**1<sup>st</sup> Further Information**

**Proposed Temporary Warehouse and Open Storage of Construction Materials  
and Machineries with Ancillary Facilities for a Period of 3 Years and Associated Filling of Land  
in "Agriculture" Zone, Lots 1131 (Part), 1144 (Part), 1145 (Part), 1146, 1147 (Part), 1148 (Part),  
1149 (Part), 1150, 1212 S.A (Part) and 1212 RP (Part) in D.D. 107,  
Kam Tin, Yuen Long, New Territories**

**(Application No. A/YL-KTN/1050)**

**Responses-to-Comments**

LAYOUT PLAN

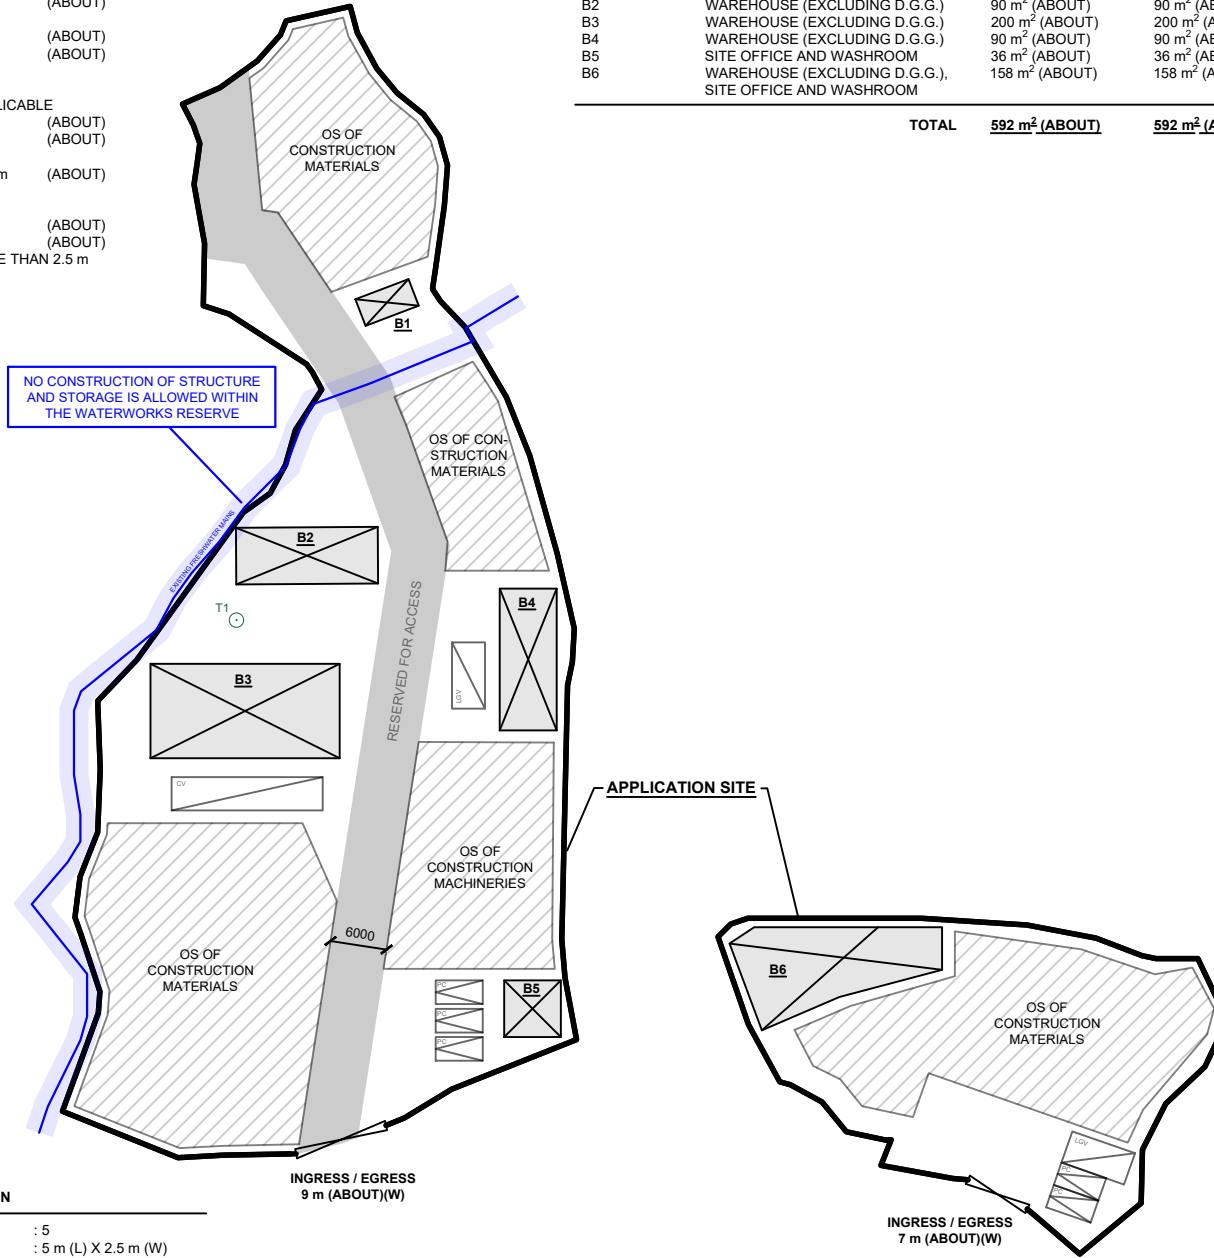
(b)	In case it is not feasible to divert the affected water mains, a waterworks reserve within 1.5 m from the centre line of the water main shall be provided to WSD. No structure shall be built or materials stored within this waterworks reserve. Free access shall be made available at all times for staff of the Director of Water Supplies or their contractor to carry out construction, inspection, operation, maintenance and repair works.	In view of the alignment of the existing water mains, the applicant has revised the layout accordingly. There will be no erection of structures and storage of materials within the extent of the said waterworks reserve.  Please refer to the revised Layout Plan at <b>Annex 1</b> .

(a)	According to the proposed layout, the proposed land filling work may be in conflict with the existing trees. However, no tree information is provided in the application, potential impact on the existing landscape resources within the site arising from the proposed use could not be reasonably ascertained. The applicant is advised to provide information on the existing trees within the application site including	The site inspection conducted on 22.10.2024 identified 1 existing tree, namely <i>Dimocarpus longan</i> within the Site. The tree survey report is enclosed at <b>Annex 2</b> . In view of the form and health condition, the applicant proposes to retain the tree in-situ.  Regular horticultural practice will be carried out to maintain the tree in good conditions. No items will be stored under the tree

location, species and sizes, general condition with photos, proposed tree treatment and mitigation measures for consideration.	protection zone. Please refer to the revised Layout Plan at <b>Annex 1</b> .
<b>3. Comments of the Commissioner for Transport (C for T)</b>

- (iii) Compared with the original submission, the applicant has revised the following parameters:
- the location of the loading/unloading space for container vehicle (moved to the south of structure B3);

DWG. TITLE  
 SWEPT PATH ANALYSIS (CV)

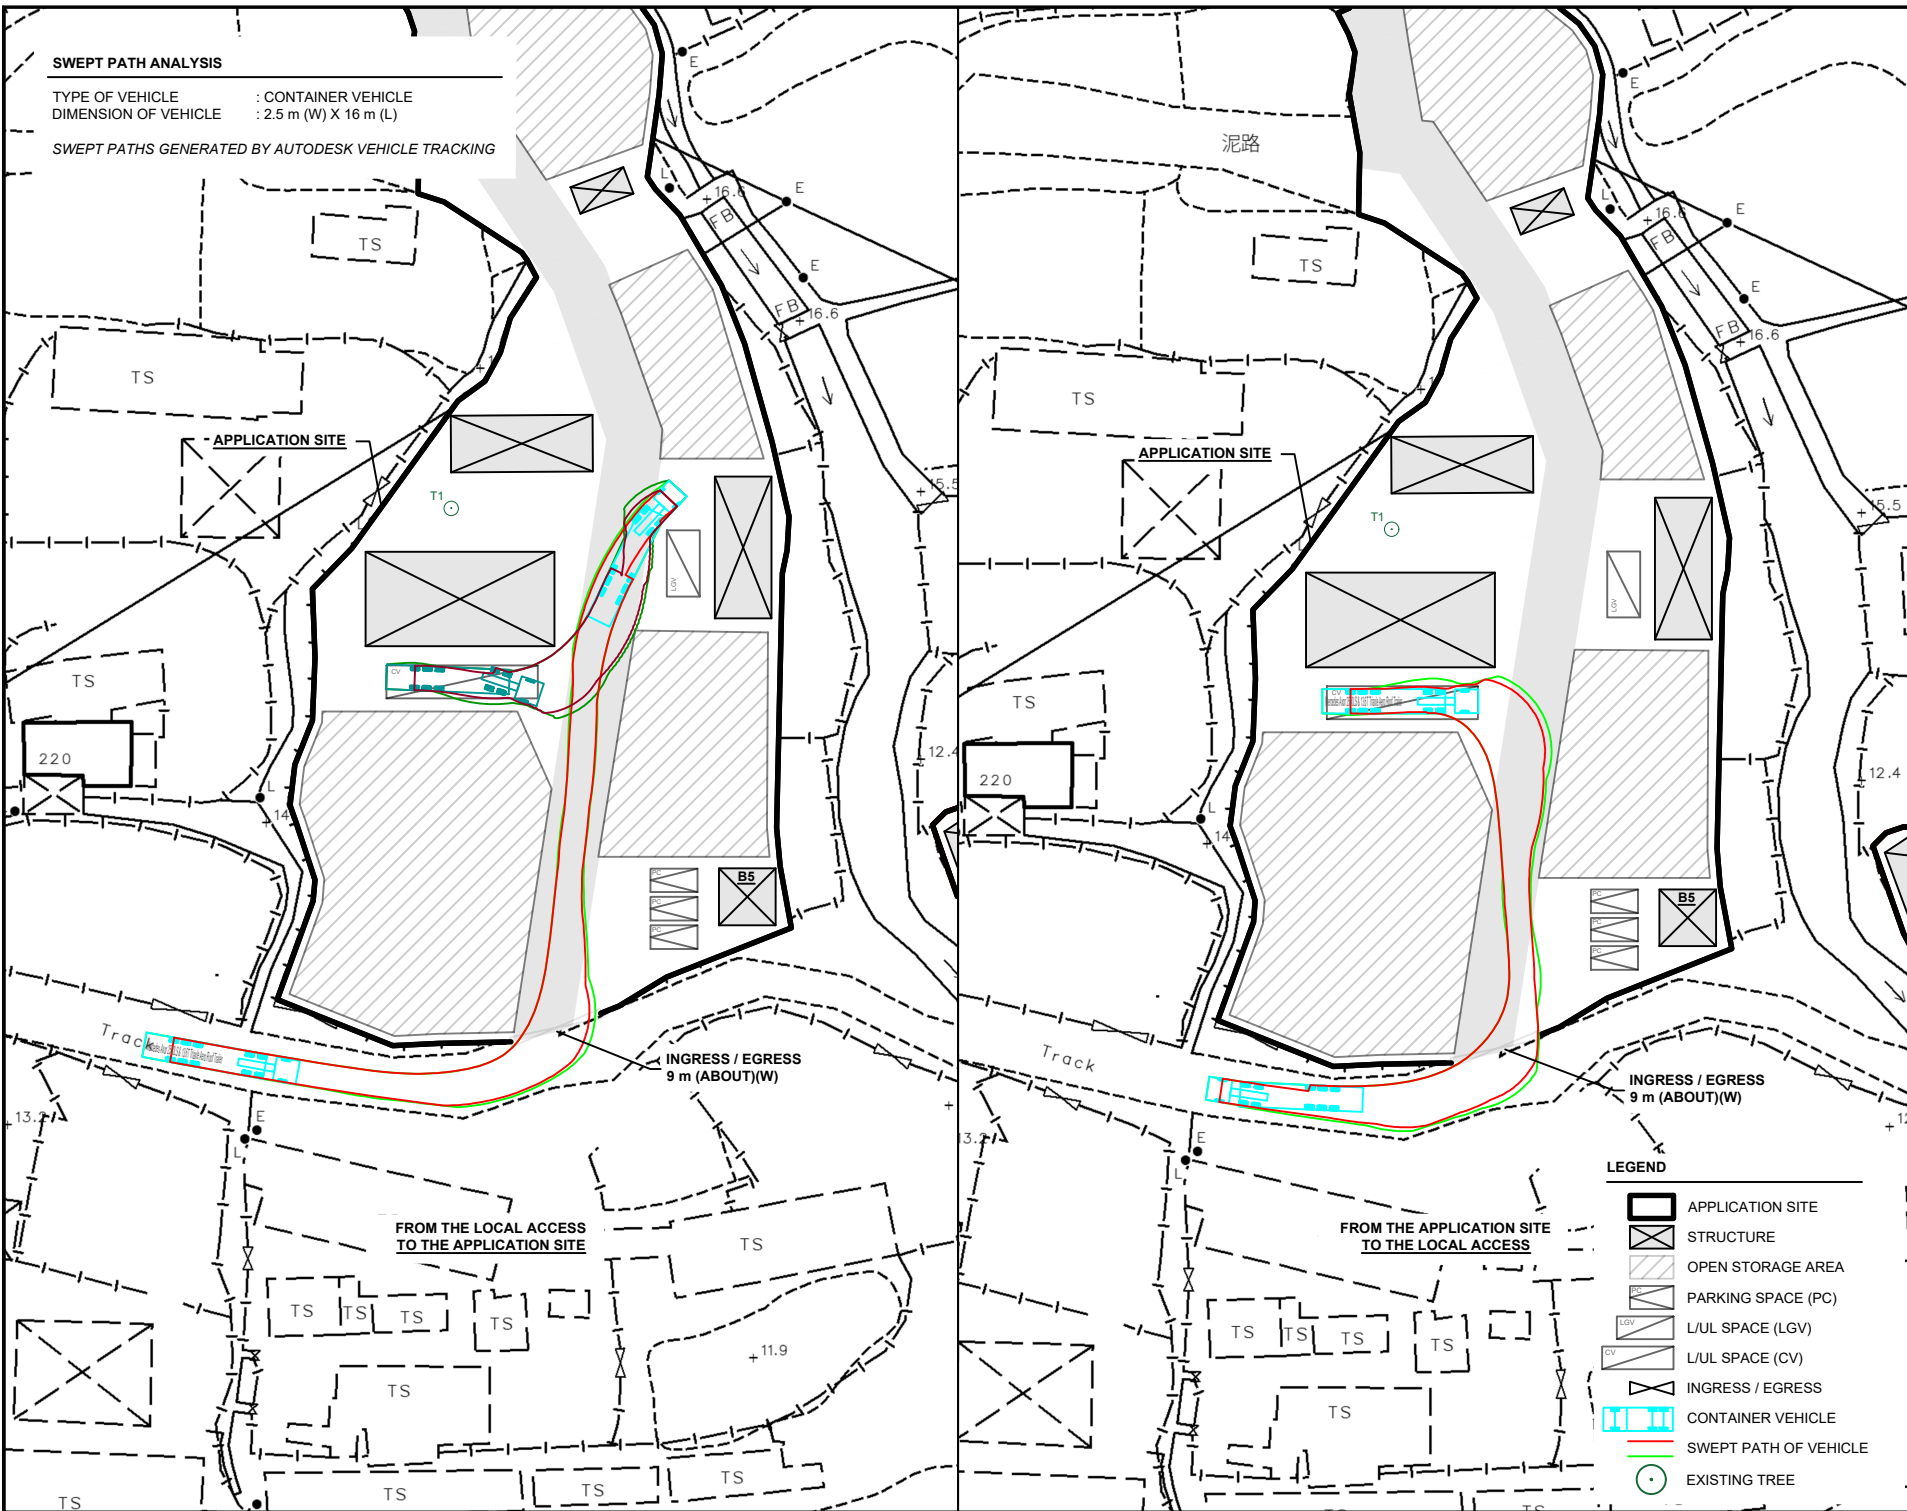
(a)	The proposed development involves container vehicles travelling in village road. Long vehicles travelling in local access may induce road safety hazard especially during the event of head on traffic. The applicant shall consider appropriate traffic management measures to reduce the risk.	<p>Staff will be deployed at the site ingress/ egress and the junction of Mei Fung Road to direct incoming/exiting vehicles to enhance road safety along the local access. Besides, 'BEWARE OF HEAD ON TRAFFIC' and 'BEWARE OF PEDESTRIAN' signs will be shown at the junction of Mei Fung Road and the site ingress/egress respectively to enhance road and pedestrian safety along the local access.</p> <p>With the implementation of the above traffic management measures, it is expected that the adverse impact on the local traffic and pedestrian safety will be minimal.</p>
<b>4. Comments of the Director of Agriculture, Fisheries and Conservation (DAFC)</b>
